Access Compliance Report

(Curb Ramps)

Intersection ID: 10038086	Main Street: SIKES_PL	Cross Street: N/A	Location: NW
ADA ID: 5620A2618575	Ramp Type: PerpDiag	Initial Pass/Fail: Fail	Overall Compliance: No
Severity Score: 22.5			
Codes/Mitigation Info/Possible Solution		Field Measurements/Component Compliance

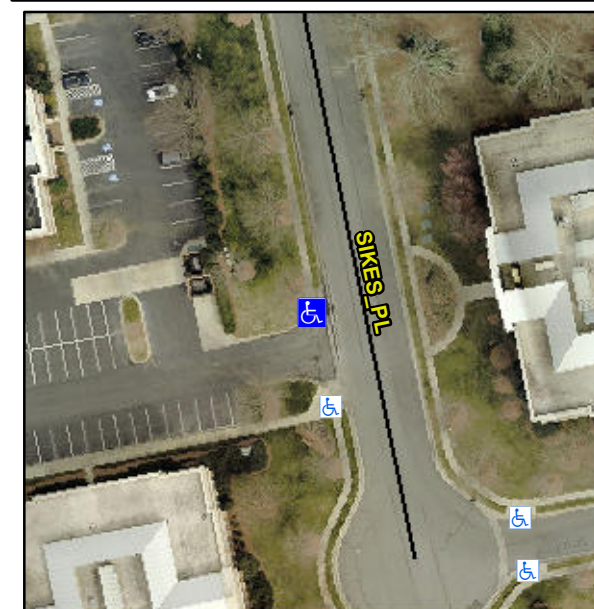
R304.5.1, R304.2.2, R304.5.3

Compliance	Description	Data	Compliance	Description	Data
N/A	Ramp Length (in)	46.0	No	Ramp Slope (%)	8.5
No	Ramp Width (in)	46.3	No	Ramp XSlope (%)	3.8
N/A	Flare Type LT	N/A	N/A	Flare Type RT	N/A
N/A	Flare Slope LT (%)	N/A	N/A	Flare Slope RT (%)	N/A
N/A	Flare Traversable LT?	N/A	N/A	Flare Traversable RT?	N/A
N/A	Landing Length (in)	N/A	N/A	DWS Provided?	N/A
N/A	Landing Width (in)	N/A	N/A	DWS Contrast?	N/A
N/A	Landing Slope (%)	N/A	N/A	DWS Length (in)	N/A
N/A	Landing X Slope (%)	N/A	N/A	DWS Full Width?	N/A
N/A	Landing Curb? (Y/N)	N/A	N/A	DWS Offset (in)	N/A
N/A	Shared Landing?	N/A			
N/A	Gutter Ponding?	N/A	N/A	Gutter Slope (%)	N/A
N/A	Gutter Lip Ht (in)	N/A	N/A	Gutter X Slope (%)	N/A
N/A	Painted X Walk1?	No	N/A	Painted X Walk2?	No
	X Walk 1 Direction	To S		X Walk 2 Direction	To E
N/A	X Walk 1 Width (in)	N/A	N/A	X Walk 2 Width (in)	N/A
	X Walk 1 Slope (%)	1.2		X Walk 2 Slope (%)	4.1
	X Walk 1 X Slope (%)	3.1		X Walk 2 X Slope (%)	1.1

Remove & Replace Curb Ramp With Two New Directional Ramps or Equivalent.
